# REPORT SUMMARY MINOR VARIANCE APPLICATION A029/24

Report Date: August 16, 2024

CITY WARD #:	1
APPLICANT:	Ron and Anna Annabelle
AGENT:	None
PROPERTY:	55 Logwood Drive, Maple
ZONING DESIGNATION:	See below.
VAUGHAN OFFICIAL PLAN (2010) DESIGNATION:	Vaughan Official Plan 2010 ('VOP 2010'): "Low-Rise Residential"
RELATED DEVELOPMENT APPLICATIONS:	None
PROPOSAL:	Relief from the Zoning By-law is being requested to permit a proposed shed.

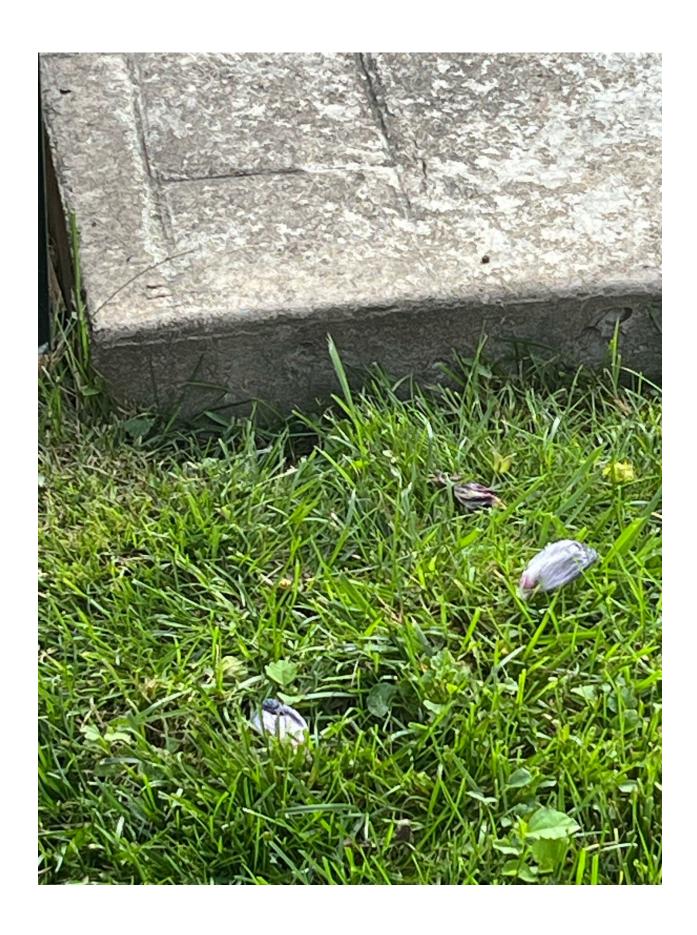
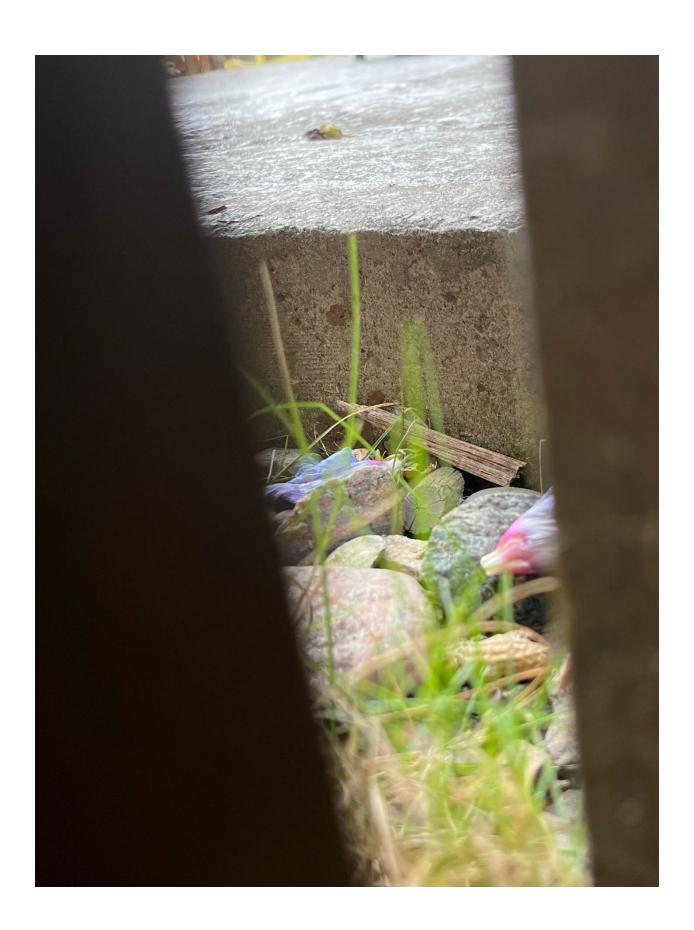
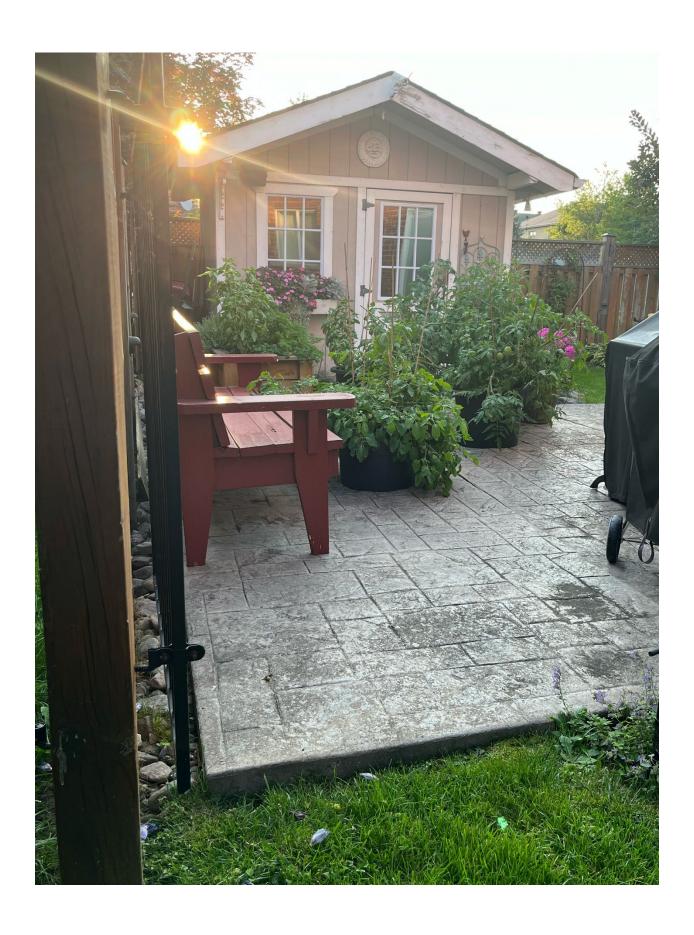
I have reviewed the Survey and it does not accurately represent the height of the shed. The survey outlines that the shed is built on a 4" slab which is below grade. This is not correct as the concrete was poured on the existing surface and is not below grade. The existing shed, is therefore 4 inches or .1016 meters higher than identified in the application. The Minor Variance Application item #1 must be amended "To permit a maximum height of an accessory building to 3.175 m."

Please find attached photos which clearly show the concrete slab is above grade

As the surveyor has misrepresented the height of the shed, please request a further measurement. I would also request the the Engineer, M. A. Persechini, sign a conflict of interest form stating that in no way they are receiving any financial or other benefit due to this misrepresentation.
